[NOTICE] Terminal Plating Change

Engineering Change Notice of Pure-Sn plating for QFP

Package : QFP

SEIKO EPSON Corporation
Micro Devices Operation Div.

Solder ability1 Steam aging	Solder ability2 High temp storage
Photo after solder dipping

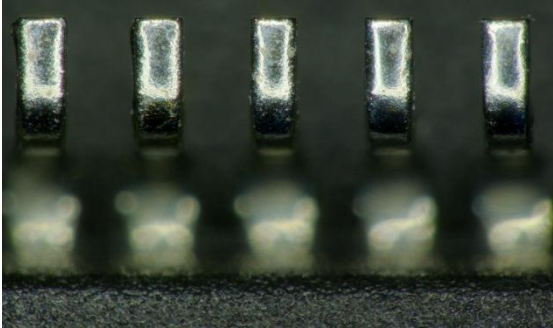
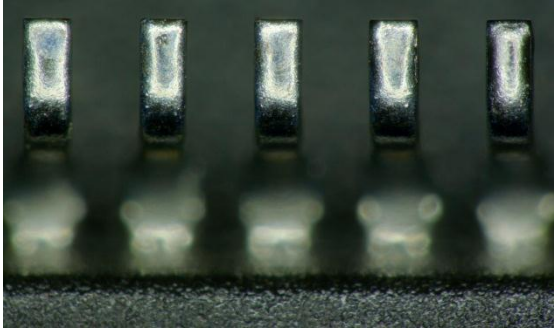
■ Solder ability1

Steam aging : 4hrs
Flux dipping time : 5~10sec
Solder temp. : 245°C
Solder dipping time : 5sec

■ Solder ability2

High temp. storage : 150°C 16hrs
Flux dipping time : 5~10sec
Solder temp. : 245°C
Solder dipping time : 5sec

■ Result

Pass. All terminal solder wets rate more than 95%

<Representative photo after 1000 cycle >

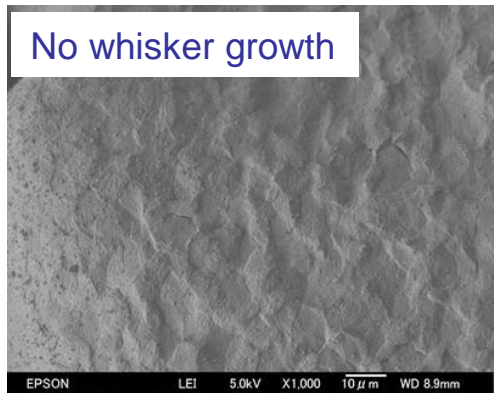
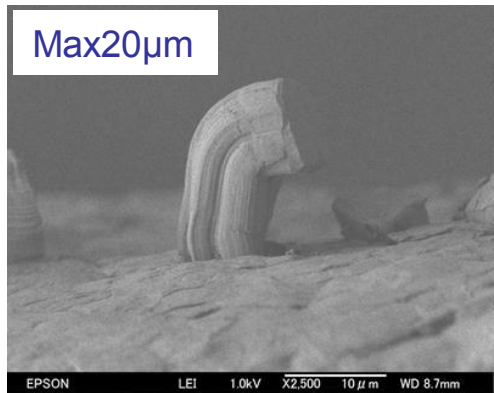
- Sample : P-LQFP048-0707-0.50(QFP12-48Pin) N=10
- Board spec.
 - Dimension : 100mm × 100mm t = 1.6mm
 - Material : FR-4
 - Layer count : 1 layer(One side board)
 - Cu layer : 35μm
 - Surface processing : Water-soluble pre-flux processing
- Solder paste : Sn-3.0Ag-0.5Cu
- Test condition : -40°C ⇔ 125°C (each 30 minute)
- Judgment criteria : A conduction part being left in the section part by section observation
- Test result : Pass. Because a conduction part is left in the section part after 1000cycle
